Design Review Board

Meeting Minutes

**Mesa City Council Chambers - Lower Level, 57 East 1st Street
Date: August 12, 2025 Time: 4:30 p.m.**

Site Plan - Amenities

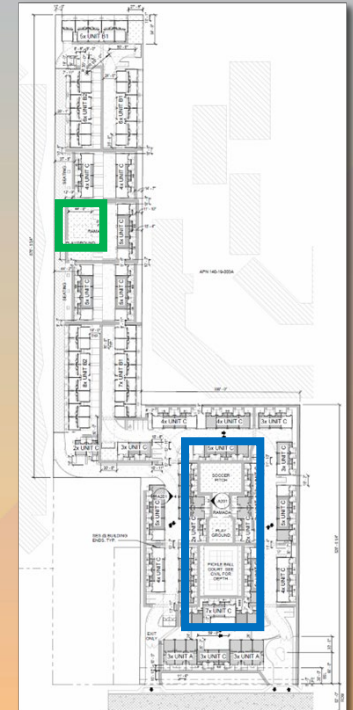
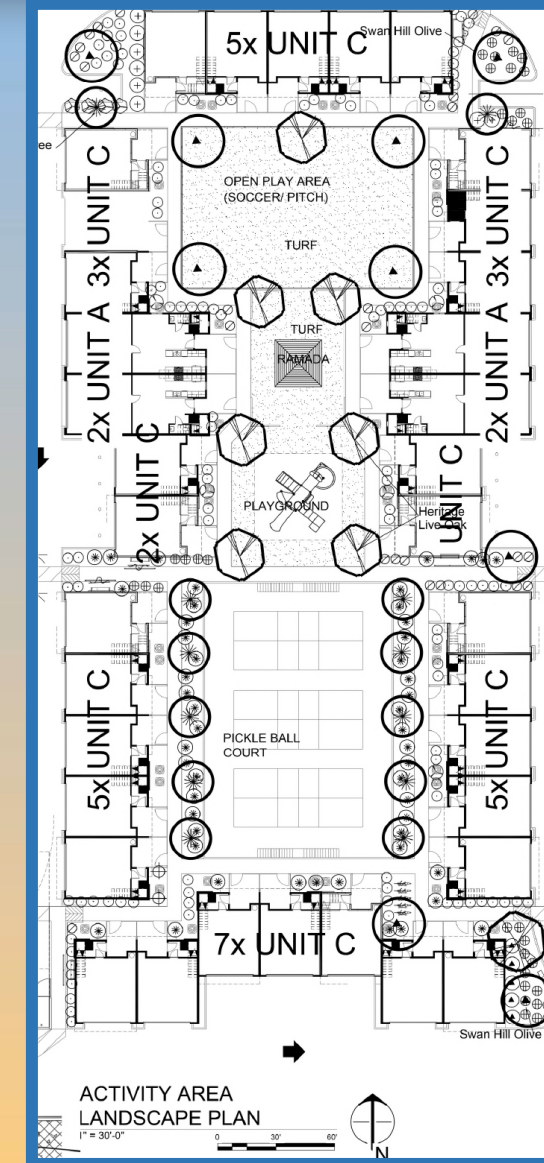
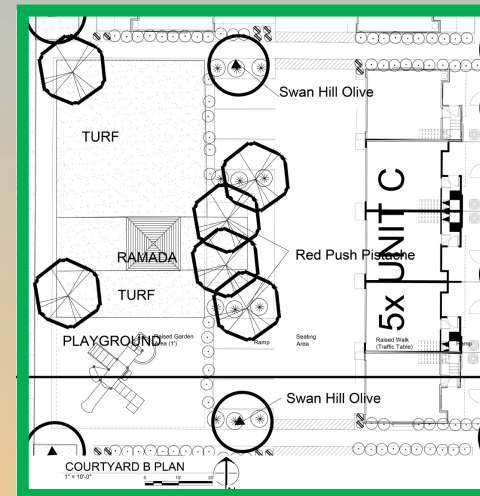
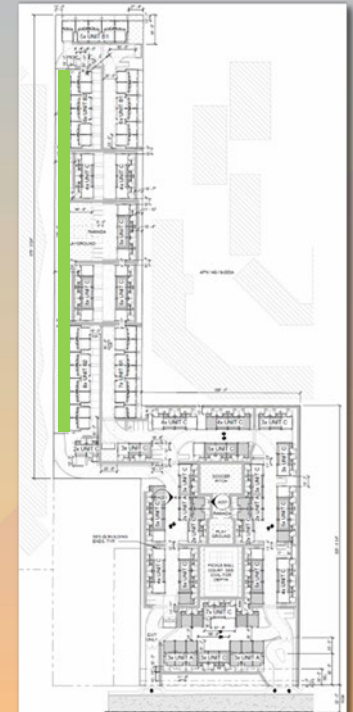
- Provide landscaping along center drive aisle in the northern portion
- End units have white flat stucco faces, incorporate articulation with reveal lines
- Select a panel material carefully to ensure the product will not buckle or fade in the desert environment
- Grass-crete becomes a maintenance issue, consider a gravel product for its durability
- Pistache trees can grow very large and may be too large for some of the spaces, consider an alternative species
- Ideally, a visual corridor to the public areas would be provided into the larger amenity area

Building Elevations

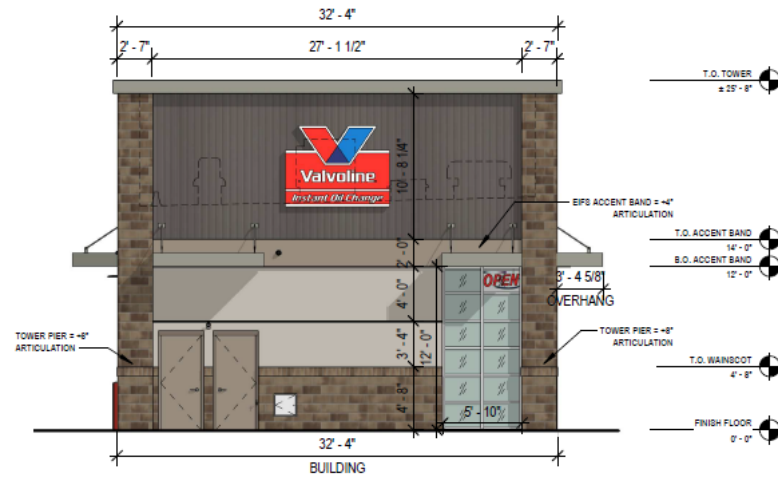
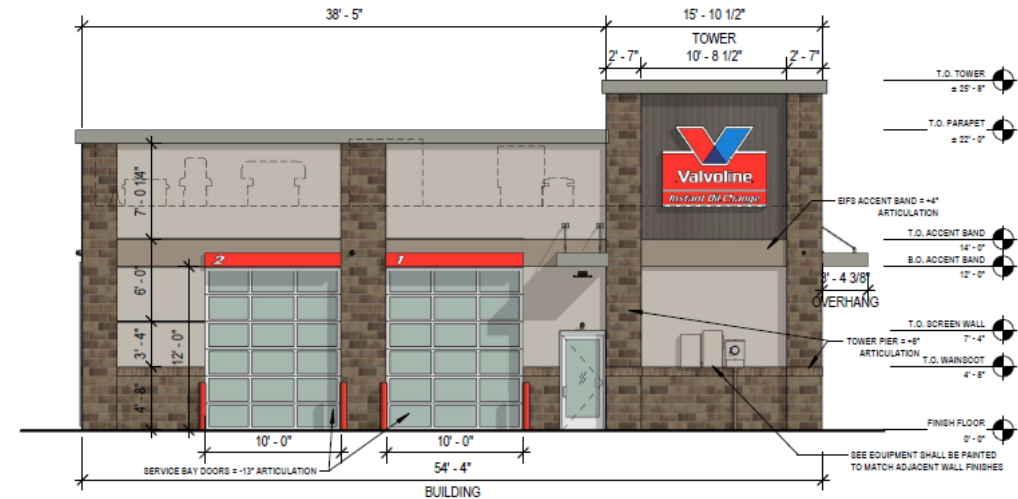
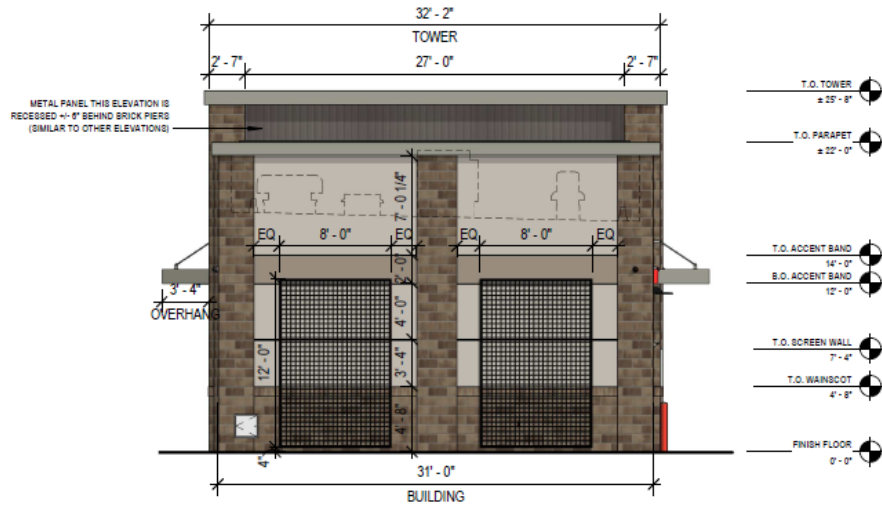
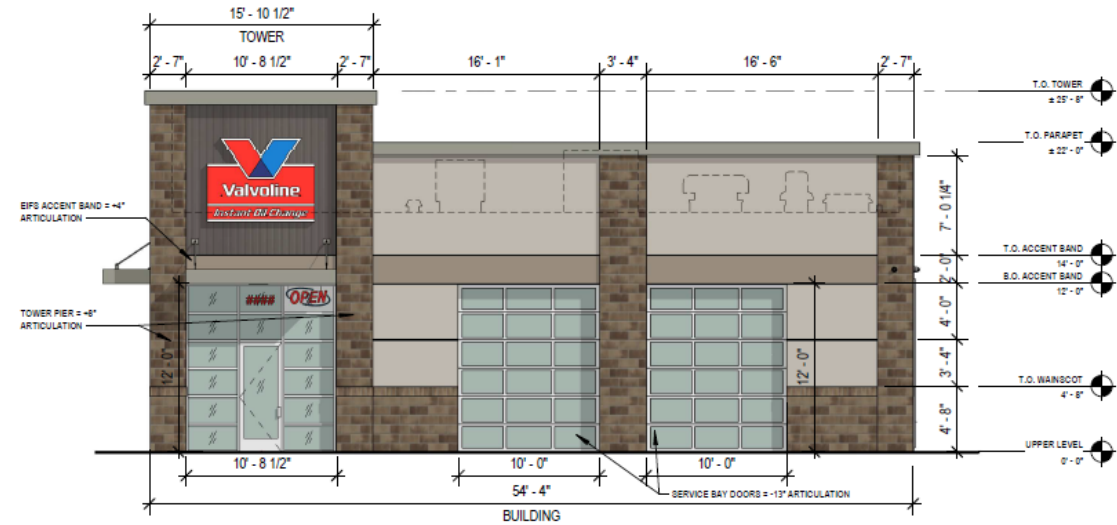
- Provide a change in plane at the stone wainscot and columns
- Provide a metal material such as Aluminum Composite Material (ACM) as coping for the top parapet treatment
